BECHTEL COMPANY
PALISADES PLANT
CONSUMERS POWER COMPANY
EQUIPMENT LOCATION - REACTOR BLDG.
PLAN OF EL. 625'-0"

5935	M-4	8
------	-----	---

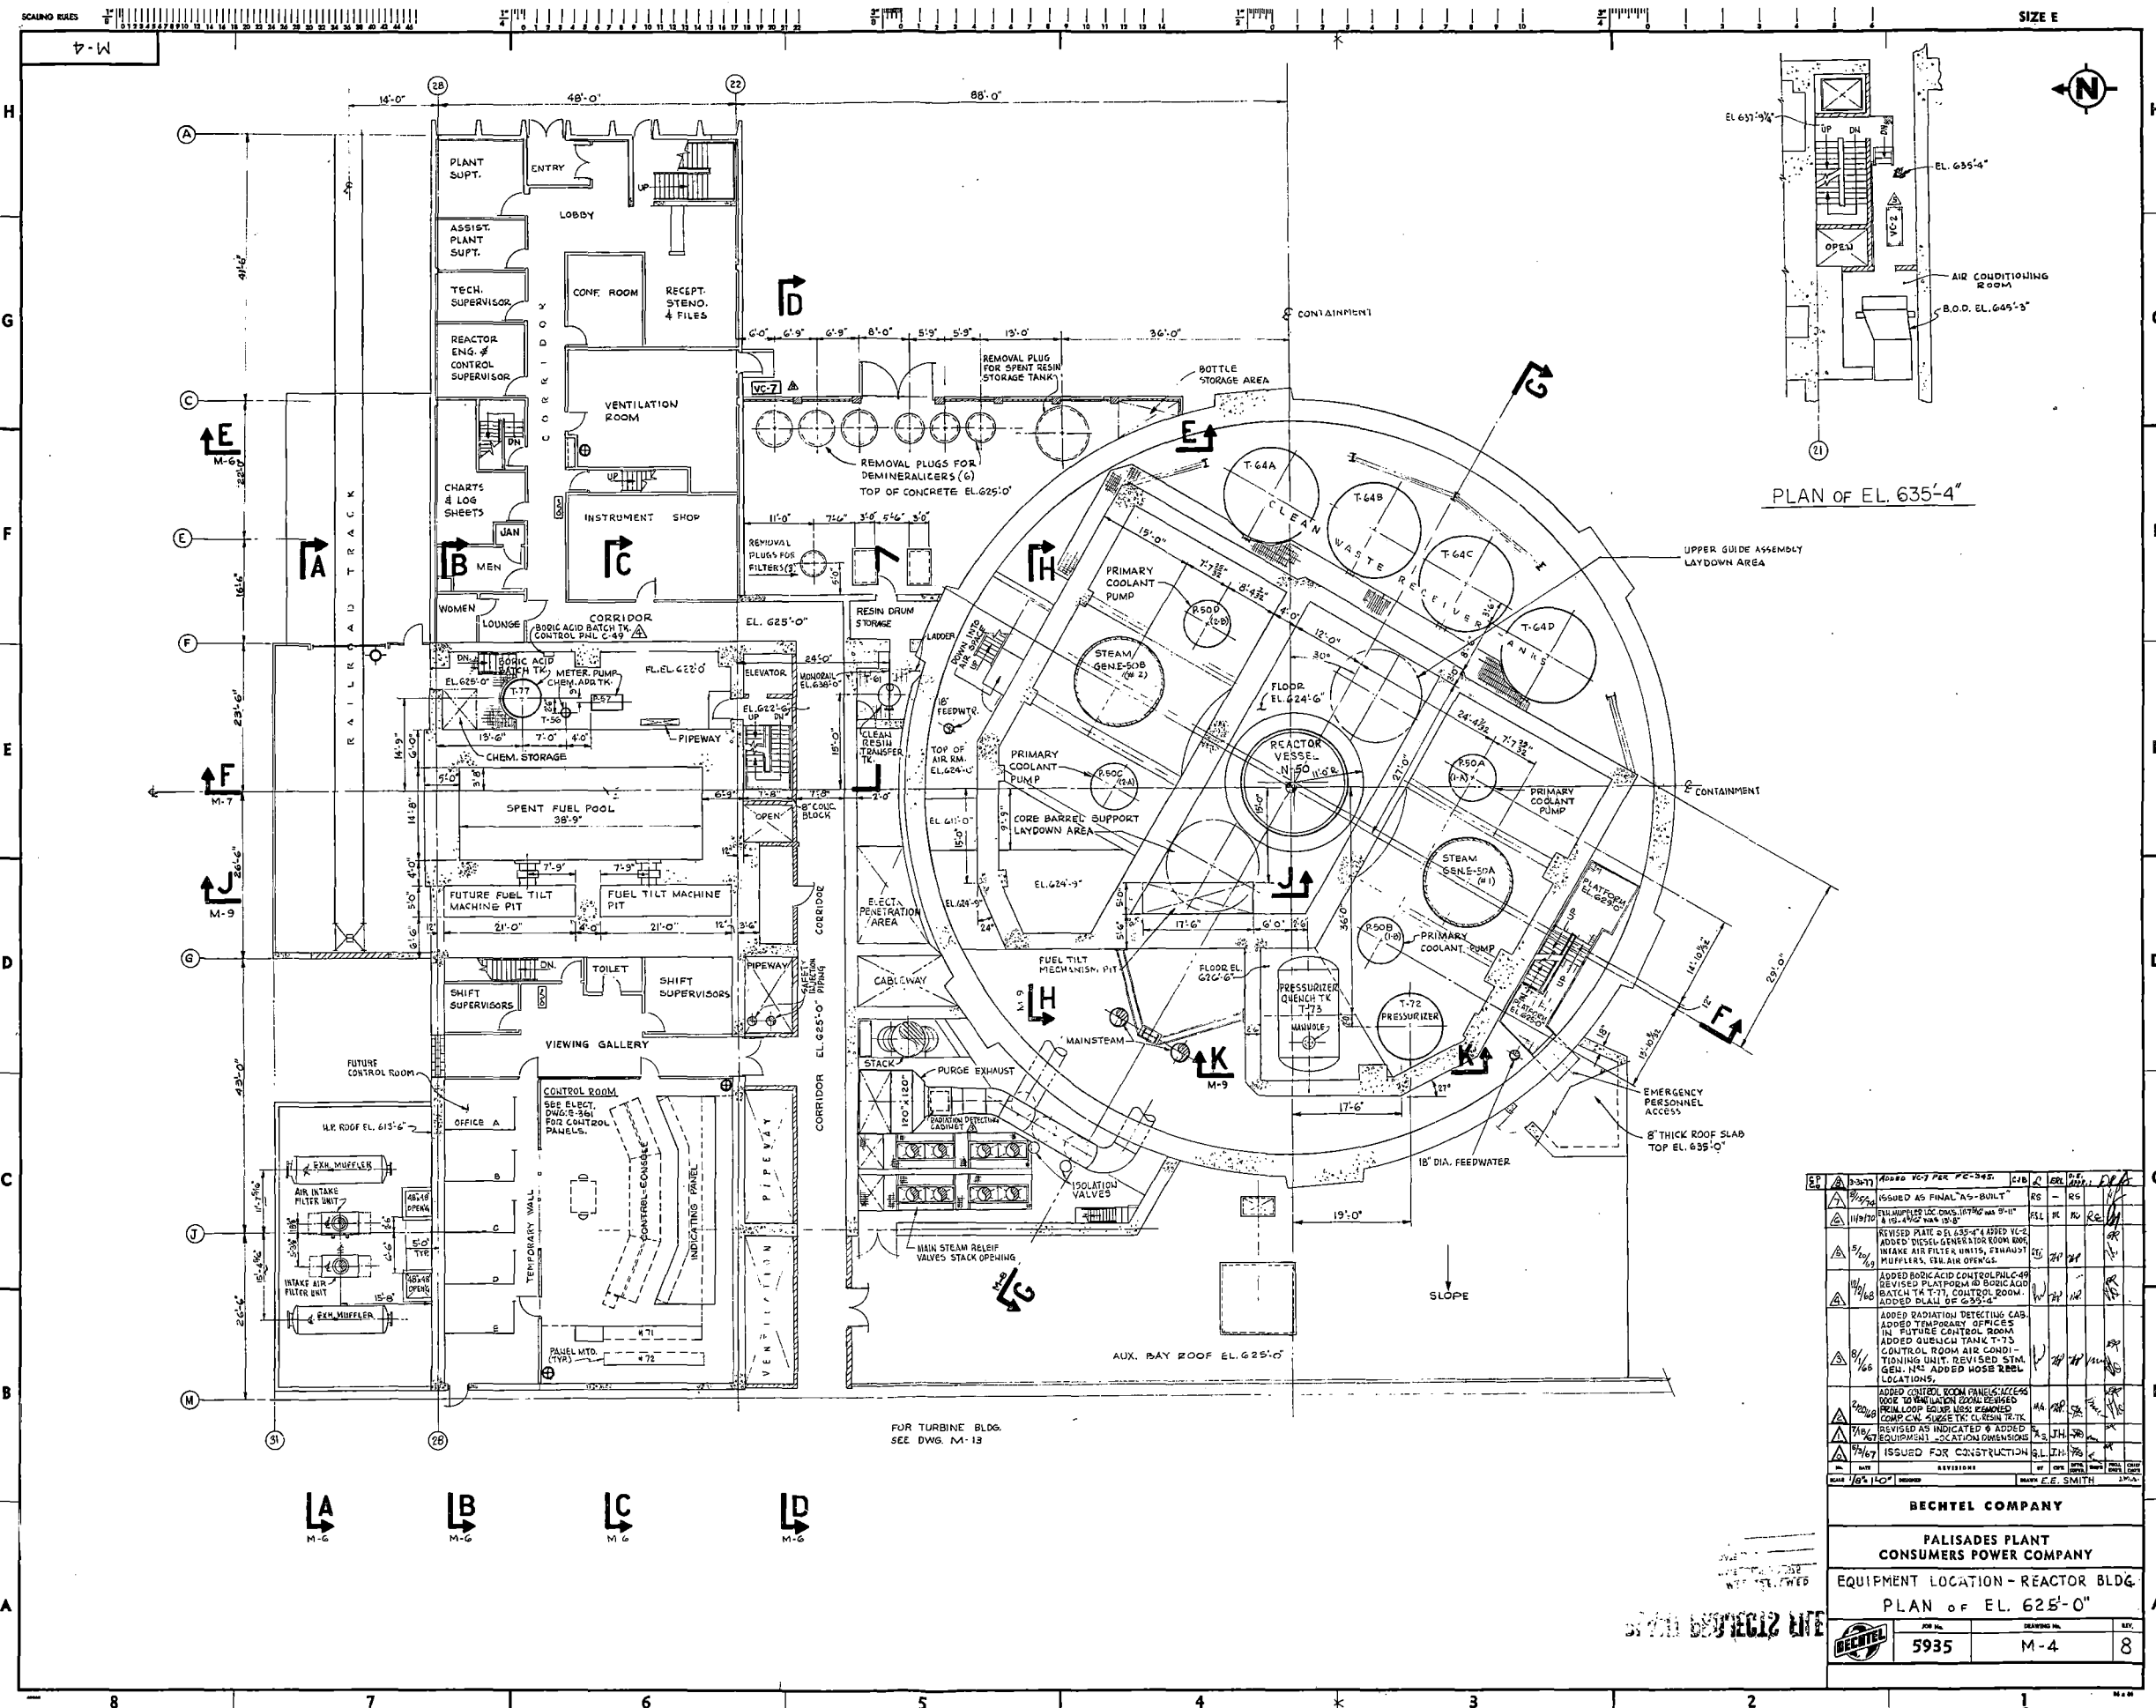
REV	DATE	DESCRIPTION	BY	CHKD	APP'D
1	10/1/67	ISSUED AS FINAL "AS-BUILT"	RS	RS	
2	11/1/70	EXHAUSTS LOC. CHG. 14790 WAS 9'-10" & 15'-4 1/2" WAS 15'-8"	SL	SL	RS
3	1/1/69	REVISED PLAT. 6 EL. 635'-4" (ADDED VC-2, ADDED DIESEL GENERATOR ROOM BING, WAKE AIR FILTER UNITS, EXHAUST MUFFLERS, 110 AIR OPEN'GS)	SL	SL	RS
4	11/1/68	ADDED BODIC ACID CONTROL PANEL C-49, REVISED PLATFORM 65 BODIC ACID BATCH TA T-71, CONTROL ROOM, ADDED PLAT. 65 65'-4"	SL	SL	RS
5	8/1/68	ADDED RADIATION DETECTING CAB., ADDED TEMPORARY OFFICES IN FUTURE CONTROL ROOM, ADDED QUENCH TANK T-73, CONTROL ROOM AIR CONDITIONING UNIT, REVISED SLM GEN. NO. ADDED HOSE REEL LOCATIONS.	SL	SL	RS
6	2/20/69	ADDED CONTROL ROOM PANELS, 110 REEL ROOM TO VENTILATION ROOM, REVISED FROM LOOP EQUIP. USED REMOVED COMP. C.W. PLUGS TO CLEAN TR. TK.	SL	SL	RS
7	7/1/67	REVISED AS INDICATED & ADDED EQUIPMENT LOCATIONS DIMENSIONS	SL	SL	RS
8	7/1/67	ISSUED FOR CONSTRUCTION	SL	SL	RS
